PLANNING, ZONING, & BUILDING DEPARTMENT
PZ&B Staff Combination Memorandum: Architectural Commission and Town Council

SUBJECT: ARC-23-109 (ZON-23-084) 600 TARPON WAY (COMBO)

MEETING: OCTOBER 25, 2023 ARCOM
NOVEMBER 15, 2023 Town Council

Building Height Plane Encroachment Diagram

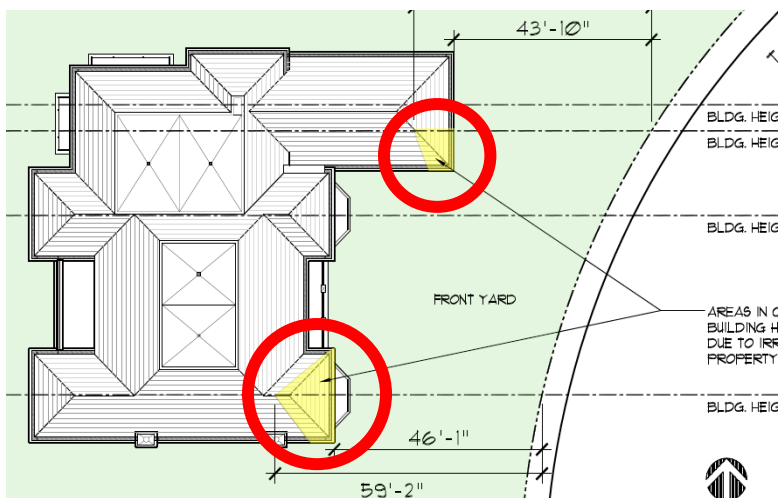
As the diagram to the left illustrates, **Variances 1 and 2** occur where two portions of the building's roof intersect with the building height plane.

The building height plane is a height limiting angle that extends at an incline from the intersection of the front property line and the property's code prescribed zero datum (7' NAVD) at a rate of two feet (2') of front setback for every one foot (1') of building height.

Code Section	Required	Proposed	Variance
Variance 1: Sec. 134-843(7):	Building Height Plane of 52'-8"	Building Height Plane of 43'-10"	8'-10" GARAGE WING ROOF
Variance 2: Sec. 134-843(7):	Building Height Plane of 59'-2"	Building Height Plane of 46'-1"	13'-1" RESIDENCE SOUTH ROOF

**Mechanical Equipment Enclosure
 Front Yard Encroachment Diagram**

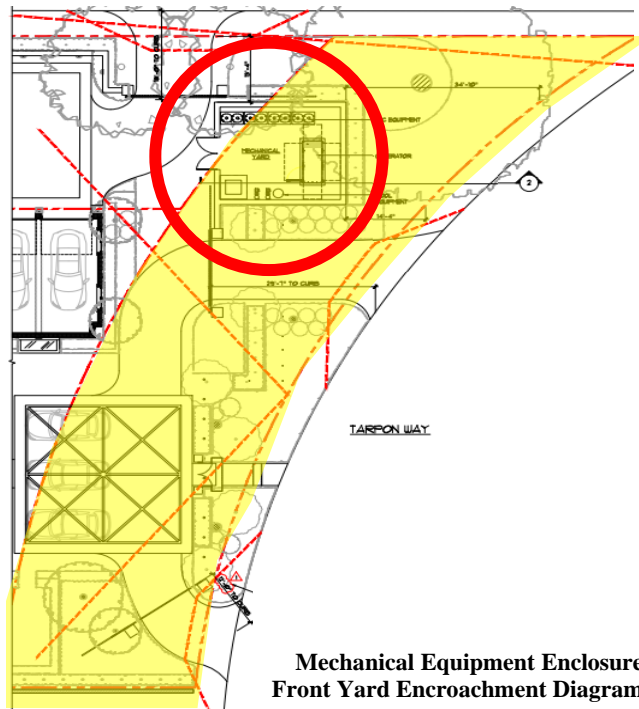
Variances are also required for the proposed location of the property's equipment yard. The equipment yard is located within the front yard's 35' setback, indicated in yellow on the graphic to the right. The equipment yard contains the property's AC condensing units (**Variance 3**), a 60kW generator (**Variance 4**), and the pool equipment (**Variance 5**) – all of which are prohibited within the front yard setback.

Additionally, when pool equipment is located within a required yard area, its location cannot exceed a separation distance greater than 25 linear feet from the pool water's edge. As the pool is located at the rear of the property at a distance greater than 25' from the equipment, an additional variance for the pool equipment is required (**Variance 6**).

Wall Height Variance Diagram

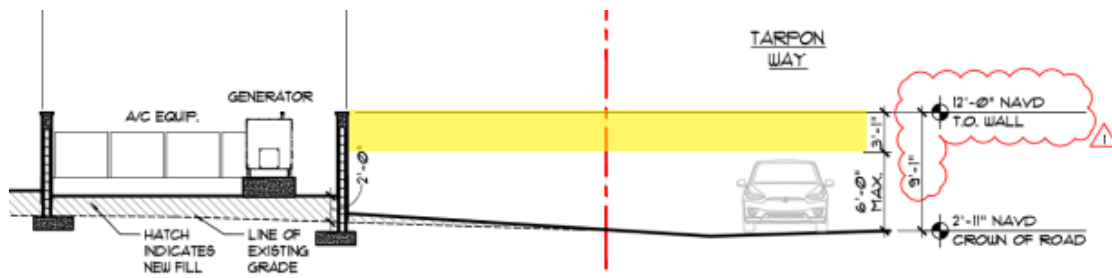
Lastly, all equipment within required yard areas shall be screened from adjoining properties with a masonry wall as high as the equipment. The applicant is proposing masonry screening walls to the top of the equipment (9'-1"), but walls located within the Front Yard Setback are limited to 6'-0" in height as measured from the adjacent crown of road. Therefore, a variance to increase allowable wall height by 3'-1" is required (**Variance 7**). The variance diagram below illustrates the 3'-1" variance amount in yellow as measured from the crown of road.

Code Section	Required	Proposed	Variance
Variance 3: Sec. 134-1728(a):	Locate AC Units Outside of Front Yard Setback	Locate AC Units within Front Yard Setback	Locate AC Units within Front Yard Setback
Variance 4: Sec. 134-1729:	Locate Generator Outside of Front Yard Setback	Locate Generator within Front Yard Setback	Locate Generator within Front Yard Setback
Variance 5: Sec. 134-1728(c):	Locate Pool Equipment Outside of Front Yard Setback	Locate Pool Equipment Within Front Yard Setback	Locate Pool Equipment Within Front Yard Setback
Variance 6: Sec. 134-1728(c):	Locate Pool Equipment within 25' of the Pool Edge when installed in a Setback	Locate Pool Equipment Greater than 25' from the Pool Edge and installed in a Setback	Locate Pool Equipment Greater than 25' from the Pool Edge and installed in a Setback
Variance 7: Sec. 134-1667:	Maximum Wall Height of 6' within Front Yard	Construct a Wall at 9'-1" within Front Yard	3'-1"

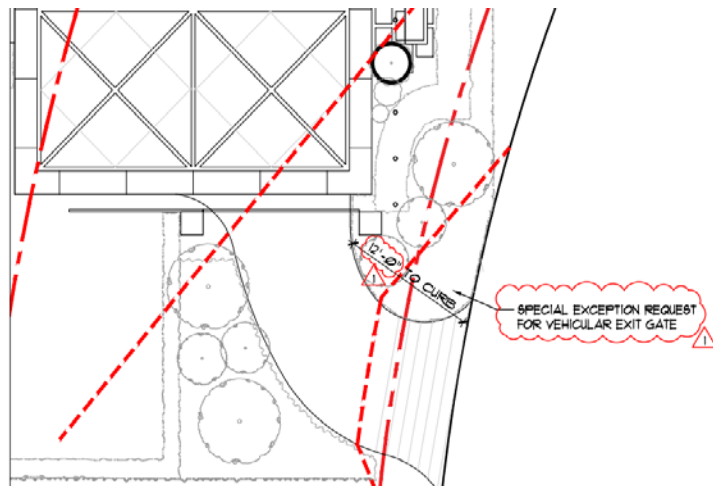
Lastly, a **Special Exception** is requested from the Town Council to permit a new vehicular gate at the south end of the front circular driveway. The proposed gate has a 12' setback from the edge of pavement in lieu of the 18' setback required for vehicular queuing.

Typically, a request to reduce a vehicular gate setback requires a variance, but as Tarpon Way is a dead-end street terminating at Tarpon Island, a Special Exception is required.

Code Section	Required	Proposed	Exception
Special Exception Sec. 134-1668:	18' Minimum Vehicular Gate Setback	12' Vehicular Gate Setback	6'-0" Reduction
